SRP Proposal to IEEE 802.1AVB

Shlomo Ovadia & Zong Liang Wu
January 25, 2007

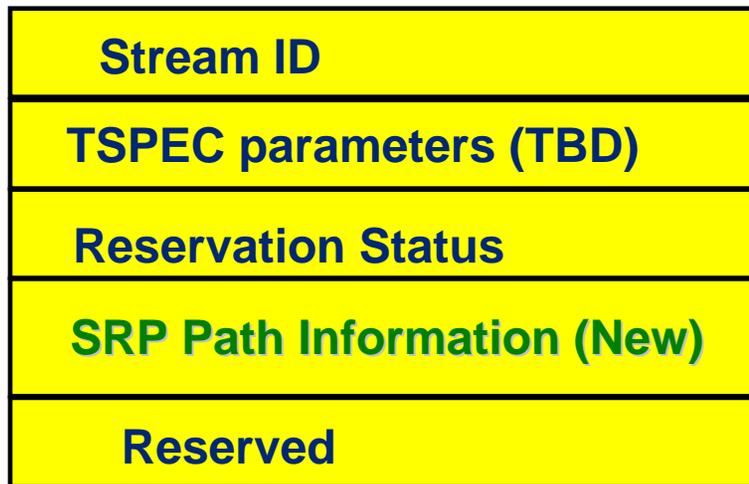
Purpose:

To identify the Ingress node that has a specific QoS flow ID (Nice to have feature)

Usage Case:

Node to match a specific AV stream needed for an end-user application (e.g. media player)

Transaction has the following primitives:

- Talker node sends FLOW QUERY request primitive to all the nodes, input parameter is the Flow ID
- Nodes that has the Flow active on them send ACK response with the following query results:
 - Requested flow found
 - Tspec

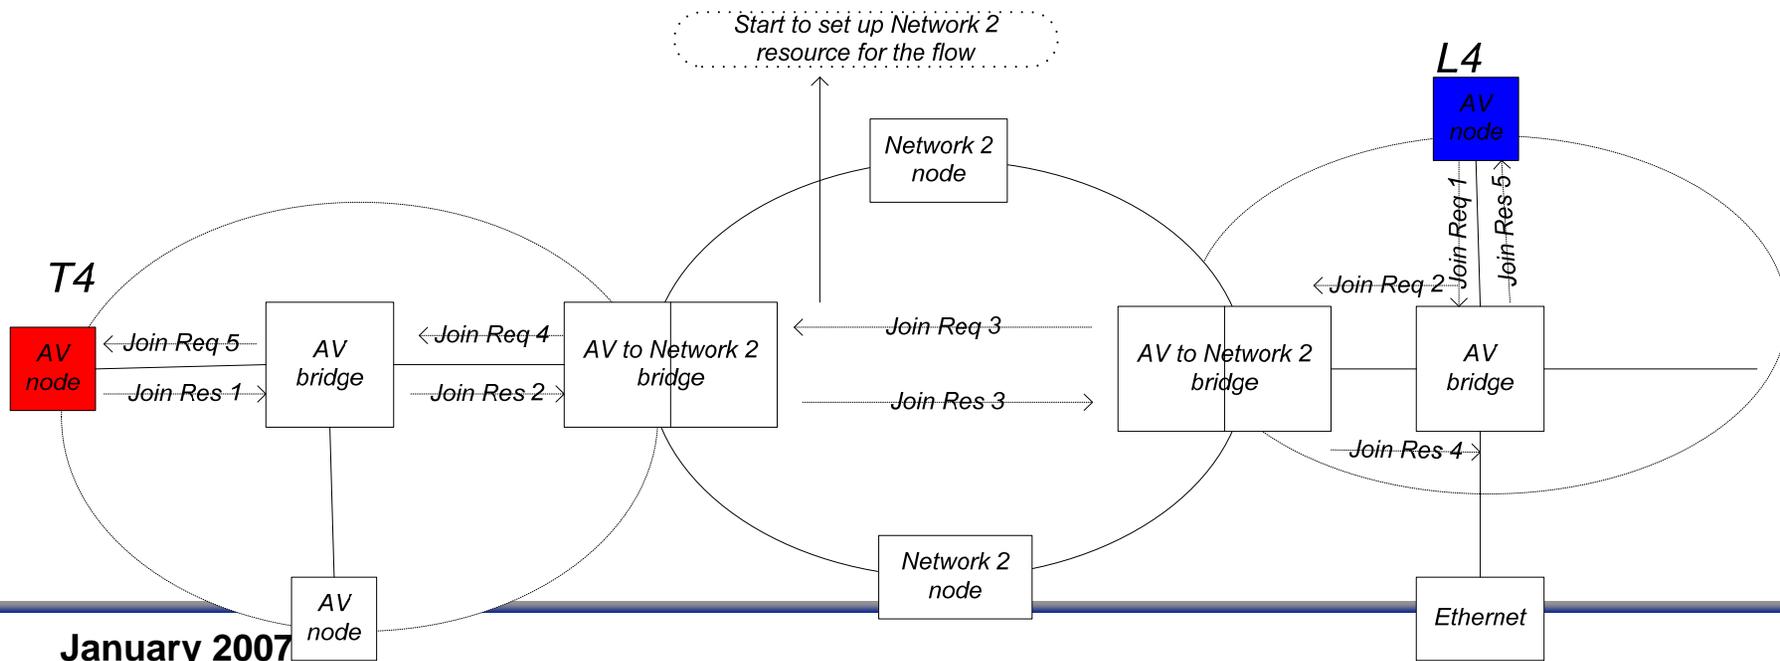
Problem Statement:

Dynamic flow reservation update needs to allow switching between different Tspecs (e.g., HD vs. SD video, or trick mode), without having to tear down and then create a new flow

Without Dynamic Update:

- **Must create a new flow and tear down the existing flow**
 - First Create then Tear down: Create may fail due to BW limitation
 - First Tear down then Create: discontinuity of flow

With Dynamic Update:

1. **Use Create Flow for both creating a new flow and updating an existing flow**
 - Intermediate nodes may succeed or fail the update operation just like they may succeed or fail the creation of a flow.
 - If the flow already exists, then the command is considered as updating an existing flow; otherwise it is considered as creating a new flow.
2. **Use Update Flow to explicitly update an existing flow.**
